SUBJECT: COMANCHE PEAK NUCLEAR POWER PLANT, UNITS 3 AND 4
DOCKET NUMBERS 52-034 AND 52-035
SUPPLEMENTAL RESPONSE TO REQUEST FOR ADDITIONAL INFORMATION
NO. 3294 (SECTION 9.1.5), 6158 (SECTION 6.4), AND 6222 (SECTION 3.9.6)

Supplemental Response to Request for Additional Information No. 3294 (CP RAI #52)

**Supplemental Response to Request for Additional Information No. 6158
(CP RAI #240)**

**Supplemental Response to Request for Additional Information No. 6222
(CP RAI #244)**

Figure 1 – MCR Chlorine Concentrations for Virtual Source Method

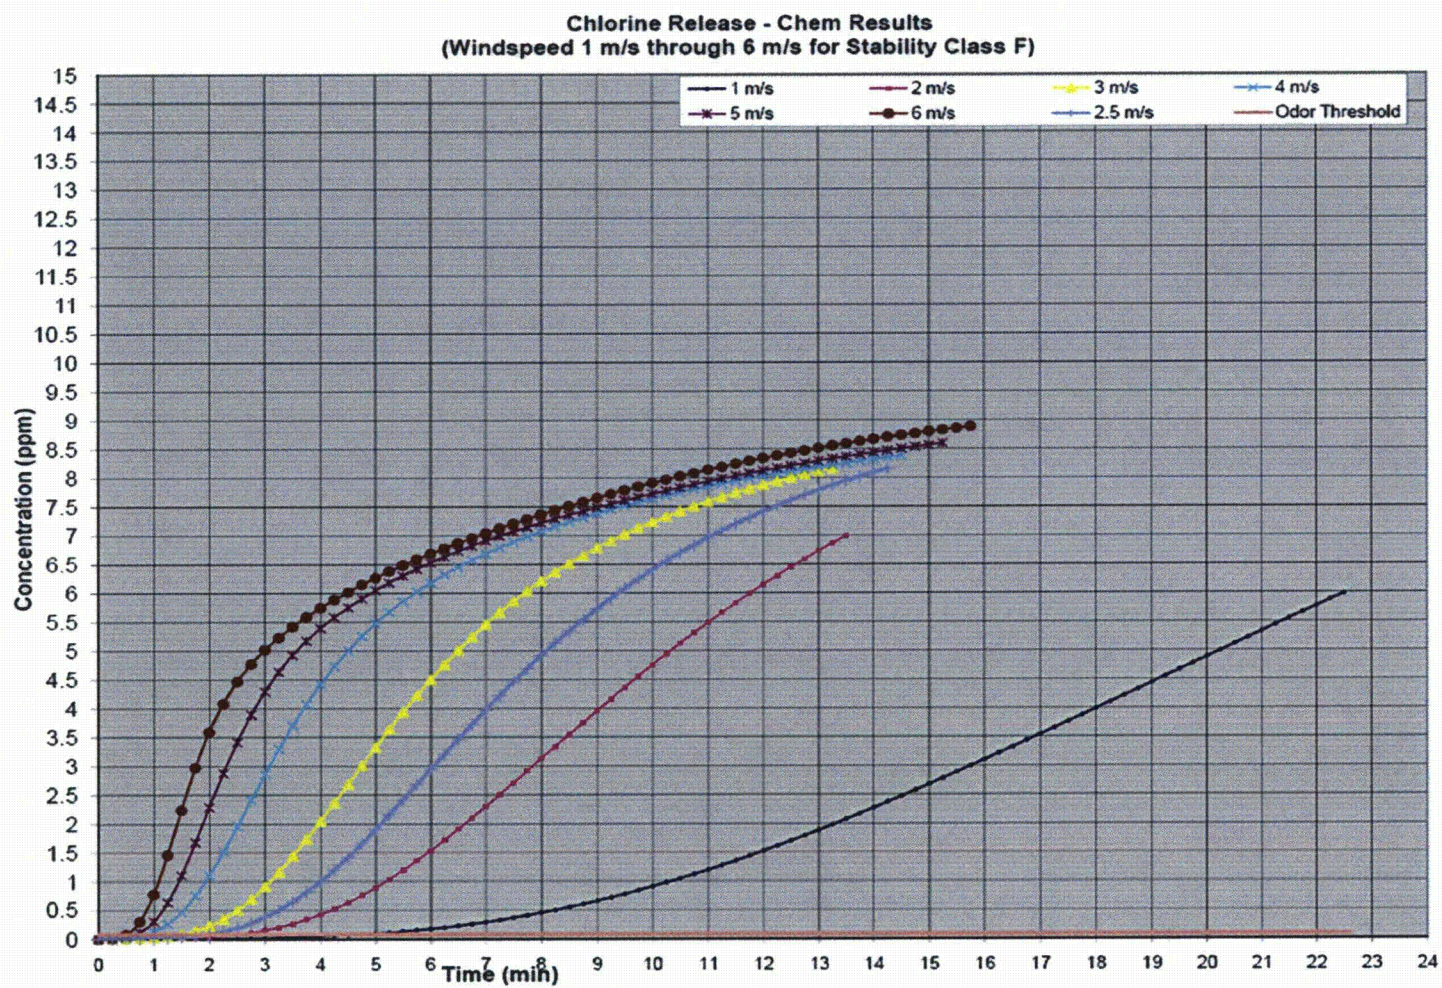
The staff also notes that both the applicant's and the staff's HABIT modeling illustrate the sensitivity of the EXTRAN results to the parameter of MCR intake height. The staff believes that the MCR HVAC intake height used in the habitability analyses needs to be captured as a plant attribute in FSAR 6.4.4.2 "Toxic Gas Protection". The staff requests that the applicant revise FSAR 6.4.4.2 accordingly.

In summation, the staff posits that since chlorine and sulfuric acid clearly fit the definition of a heavy gas that ALOHA modeling is the more appropriate program (i.e. as opposed to HABIT) to use for determining MCR habitability. More specifically, the use of the HABIT Gaussian model may be producing non-conservative results for these two heavy gases. The staff requests that the applicant re-evaluate their findings of FSAR 6.4.4.2 and address the fact that chlorine and sulfuric acid are heavy gases and provide a comprehensive justification for why the results are appropriate and conservative.

Virtual Source Calculation

The heavy gas dispersion model in ALOHA was used to determine the distance from the postulated chlorine source to the nearest location where a 1% resulting heavy gas chlorine concentration was reached under the worst-case conditions stated in the RAI. This evaluation used Pasquill Stability Class F, which is the worst-case Stability Class permitted by ALOHA. (Note that per the ALOHA manual, such stable atmosphere conditions are conservatively inconsistent with the strong solar heating conditions postulated at a 5% exceedance temperature of 36.11°C or 97°F). This distance ($D_{1\%HG}$) from the source was found to be 606 meters, while the total horizontal distance from the postulated chlorine source to the nearest control room intake is 2253 meters.

Next, HABIT runs were made at F stability and a range of wind speeds from 1 to 6 meters/second to find the worst-case distance where HABIT predicts this same 10,000 ppm concentration with its Gaussian model ($D_{1\%NB}$). This distance was calculated to be 178 meters, resulting in a final offset for the virtual source of 428 meters (606 – 178 meters). The HABIT analysis was then re-run for all wind speeds, including 2.5 meters/second, at this distance of 1825 meters (2253 – (606 – 178) meters) to the nearest control room intake with credit for the 14.3 meter control room elevation. The resulting true virtual source modeling gave MCR results as shown on the following Figure 1 plot. The plot shows the time available for a control room operator to detect a release at the odor threshold (0.08 ppm) and then take protective measures before the IDLH of a MCR concentration of 10 ppm is reached is always over 12 minutes. This is well over the 2 minutes considered by RG 1.78 as adequate time before the IDLH of a MCR concentration of 10 ppm is reached.

Accordingly, this analysis indicates the sufficiency of the previous evaluations. FSAR Section 6.4 has been revised to describe the above chlorine results. FSAR Subsection 6.4.4.2 has also been revised to add the MCR HVAC intake height (14.3 meters) that was used in the habitability analyses in order to recognize the importance of an elevated intake to provide protection for the operators.
